**RE: Miromar Lakes Phase IV
ADD2014-00102**

Enclosed please find responses to your insufficiency letter dated June 16, 2014. The following information has been provided to assist in the review and approval:

Miromar Lakes Peninsula Phase IV
DCI2014-00102
Page 1 of 2

4:1 TYPICAL LAKE CROSS SECTION
(SEE PLANS WHERE APPLICABLE) NTS

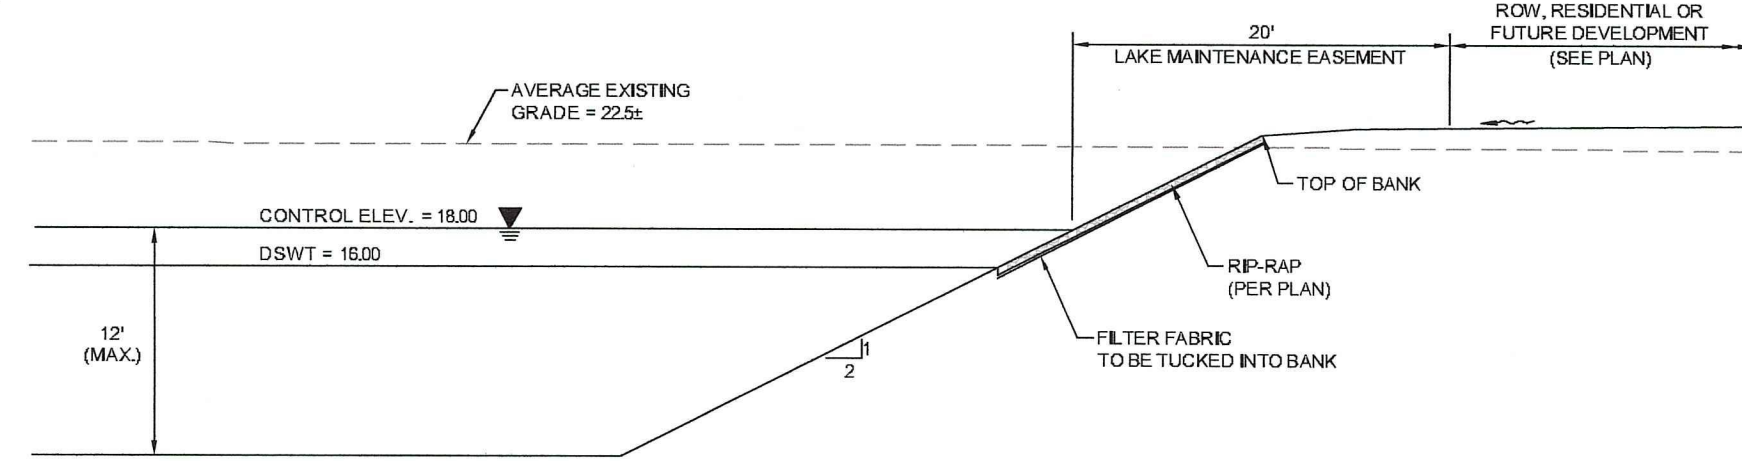
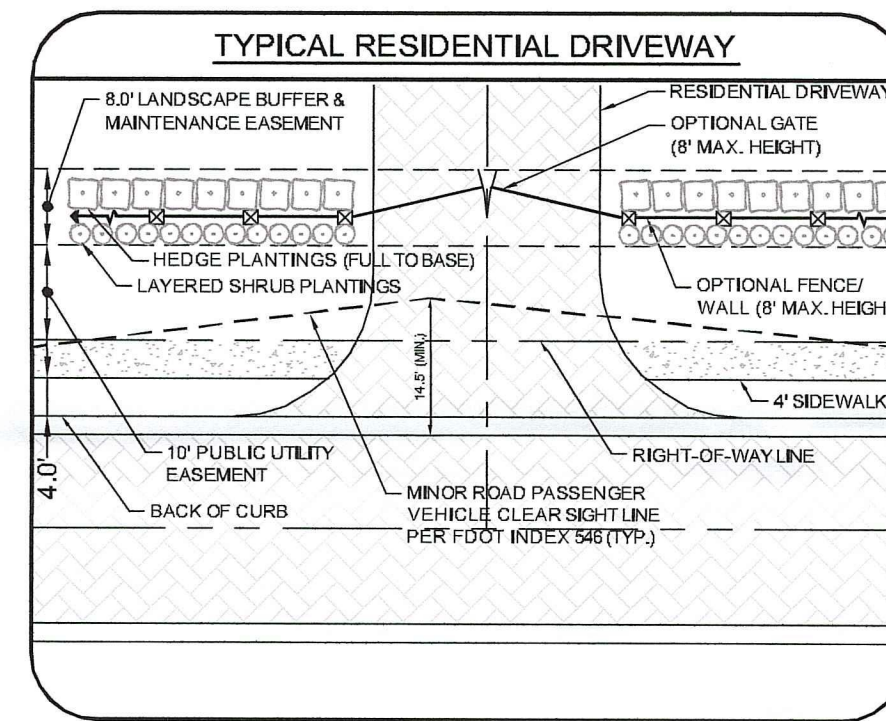
1. The deviation from 6:1 to 4:1 must demonstrate how the banks will be stabilized. Per LDC 10-329, when a deviation is sought enhanced herbaceous plants must be provided. Please provide the enhanced herbaceous plants and demonstrate how they are enhancing the 4:1 lake bank slope.

2. The lake bank slope that is being stabilized with rip-rap must provide compensatory littorals. Please label and provide a calculation on the MCP where the compensatory littorals will be installed per LDC 10-418.

RESPONSE: In accordance with the cross section on the revised FPA plan set, herbaceous plants are provided along all TRMs. As shown on the landscape plans submitted with the companion Development Order application (DOS2014-00048), the herbaceous plants are proposed in addition to the required littoral plantings. This enhancement meets the intent of LDC Section 10-329(d) to mitigate erosion.

RESPONSE: Please refer to the revised FPA plan set. The compensatory littorals have been labeled and calculations shown.

CLIENT: MIOMAR LAKES, L.L.C.
RIP-RAP EXHIBIT

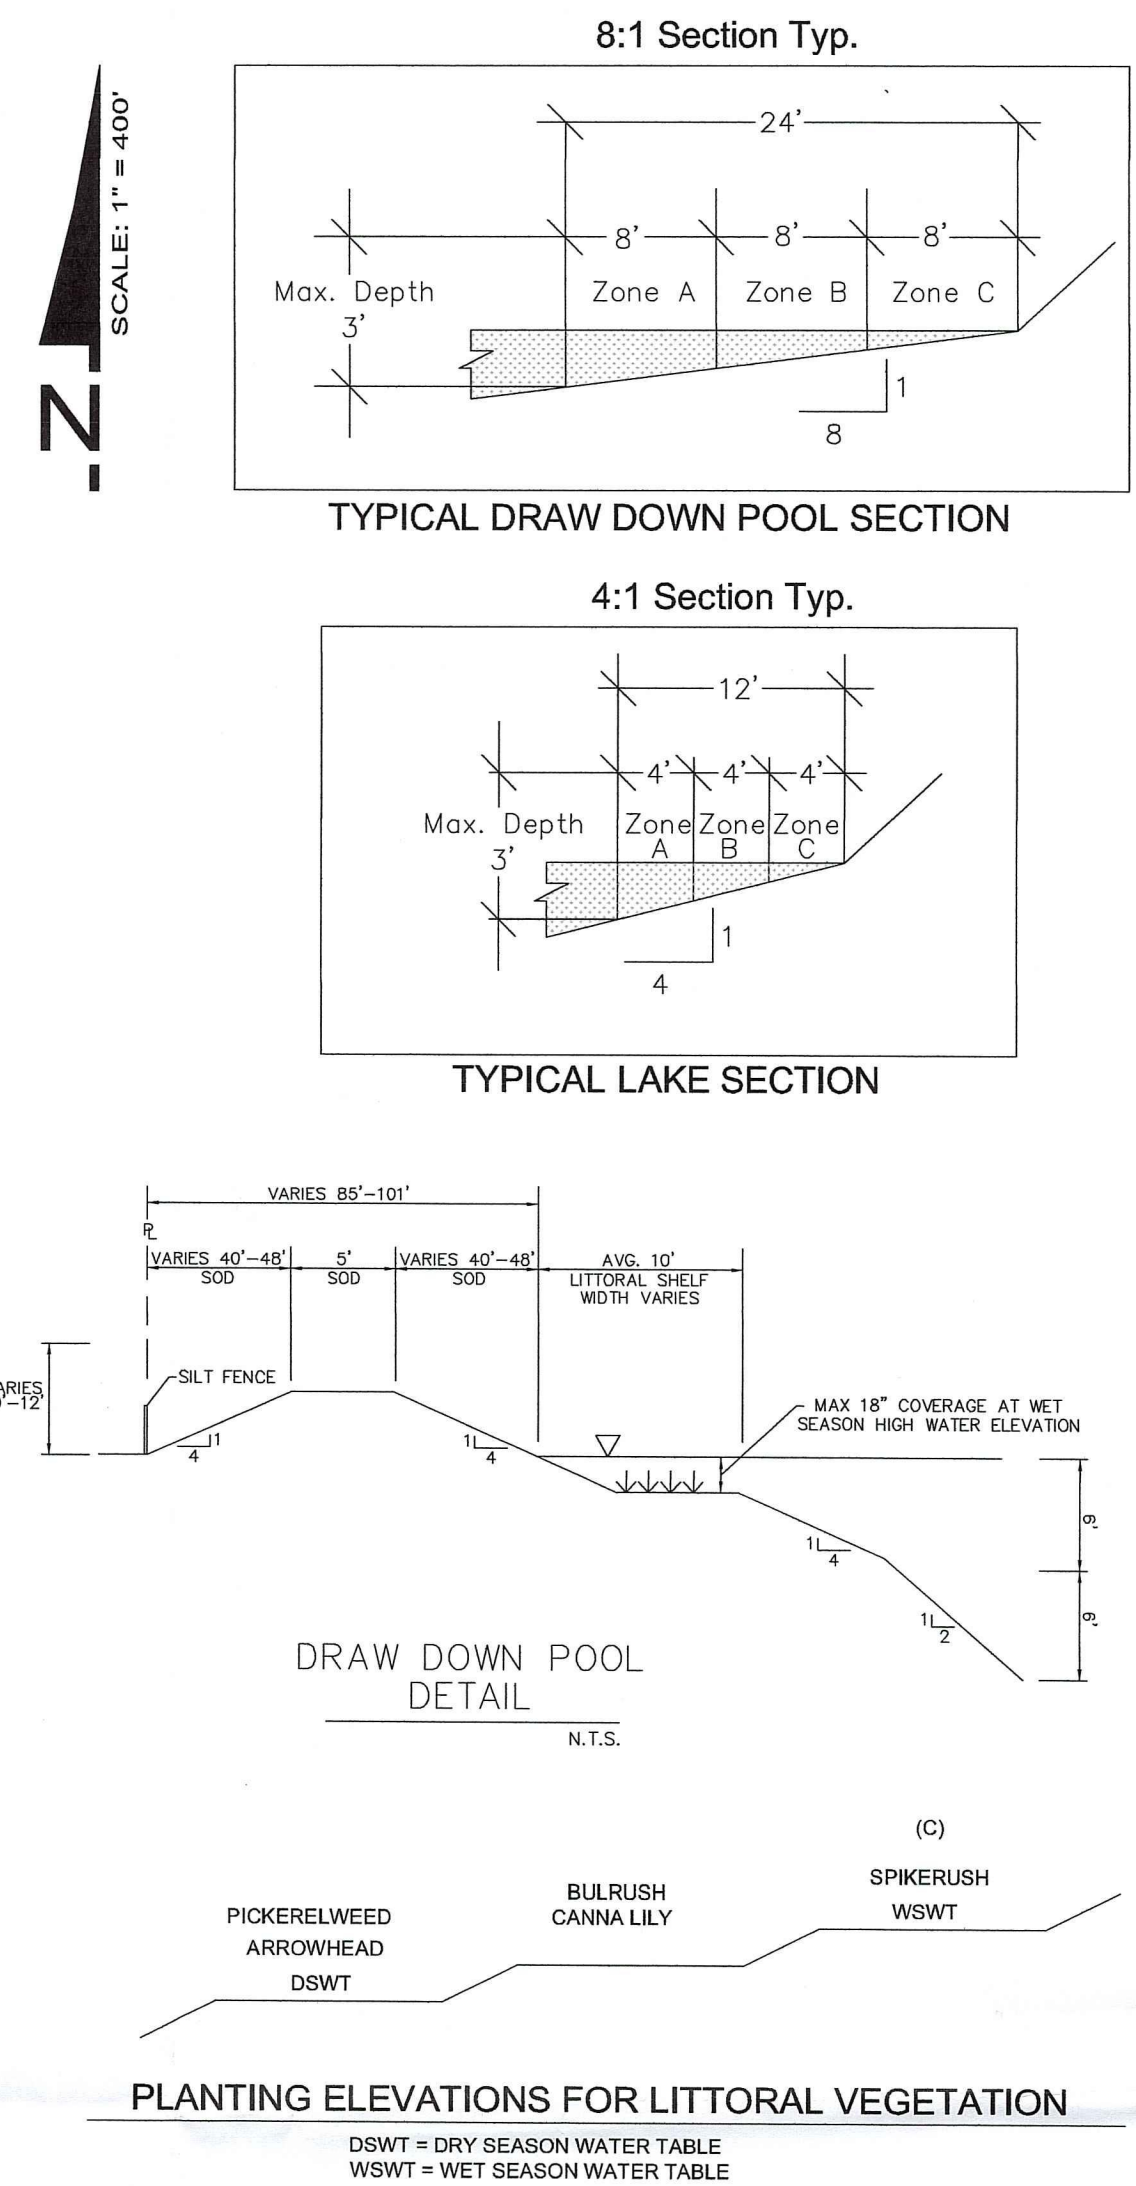
2. Deviation request from LDC section 10-329(d)(4): Lake bank slopes at 4:1. Staff understands that previous approvals limited the rip-rap shoreline to certain areas with a maximum amount. Please update the rip-rap exhibit attached to ADD2012-00110 as necessary. Due to the existing nature of the tract and the constraints of the existing lake, and previous deviation approvals, DS staff has no objection. At the time of development order, please show this limitation has not been exceeded. Note that rip-rap is not allowed adjacent to SFR development (10-418). A deviation may be required.

3. Does the amount of rip-rap being proposed in compliance with the latest rip-rap exhibit? Please provide documentation that the amount of rip-rap is within the threshold allowed for Miromar.

RESPONSE: Please refer to the attached Rip-Rap Exhibit, which demonstrates the limitation per Deviation 20 has not been exceeded. Please also refer to the revised FPA plan set and Schedule of Deviations & Justifications. A deviation from LDC Section 10-418(3) has been requested to allow for rip-rap adjacent to single-family residential lots.

RESPONSE: Please refer to the attached Rip-Rap Exhibit, which demonstrates the limitation per Deviation 20 has not been exceeded.
